MONTGOMERY COUNTY PLANNING DEPARTMENT
THE MARYLAND-NATIONAL CAPITAL PARK AND PLANNING COMMISSION

MEMORANDUM

REVIEW TYPE: Site Plan Review

PROJECT NAME: Quince Trace

Site Plan Recreation and Environmental Facilities

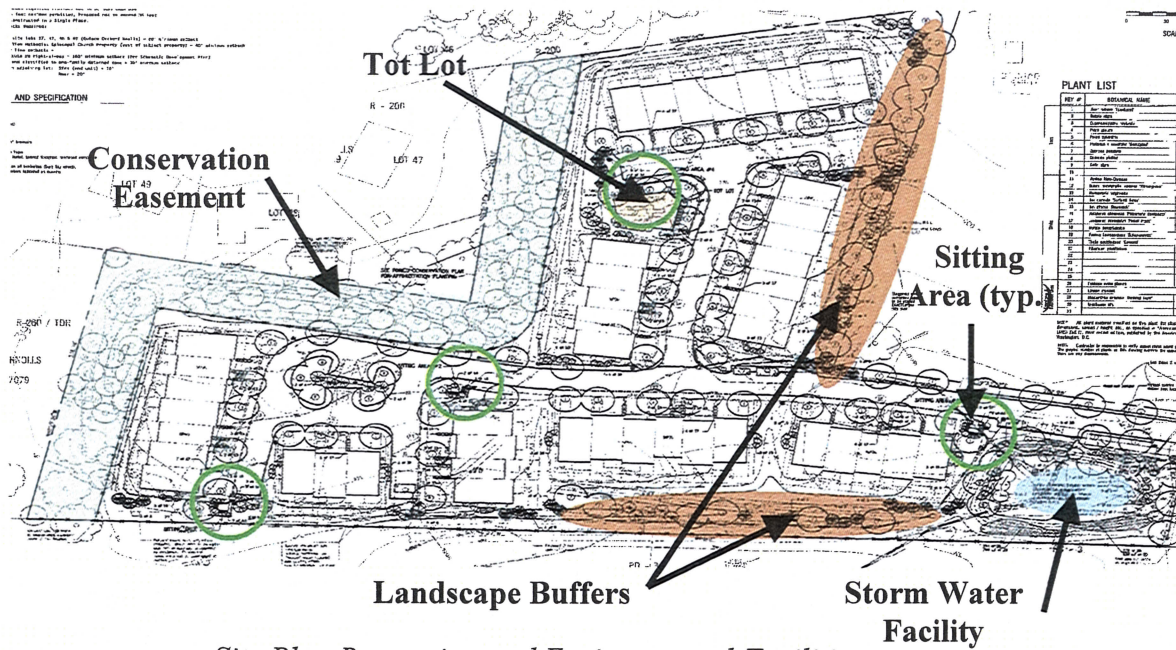
Four sitting areas spread throughout the site are proposed, including one adjacent to a tot lot being provided for neighborhood children. A system of sidewalks along the fronts of all of the townhouses and out to MD 28 connects the sitting areas, townhouses, and tot lot. Ornamental fencing is proposed at each of the sitting areas, between the tot lot and the closest private street, along MD 28, and elsewhere within the site. A proposed community sign and ornamental plantings are situated on a north-facing angle at the intersection of the entry drive and MD 28.

The proposed development exceeds the demand values for all but one population category, viz., adults, and is within 10% of the required demand for that age group. Although the tot lot is only 20 feet from the curb, planting and fencing is used to achieve the necessary compatibility and ensure safety for children according to the requirements of the Recreation Guidelines.

- a. The Applicant must ensure that the proposed recreation facilities are constructed in conformance with the approved MNCPPC Recreation Guidelines.
- b. The Applicant must provide, at a minimum, the following recreation facilities: four sitting areas, a tot lot, and an accessible pedestrian system.
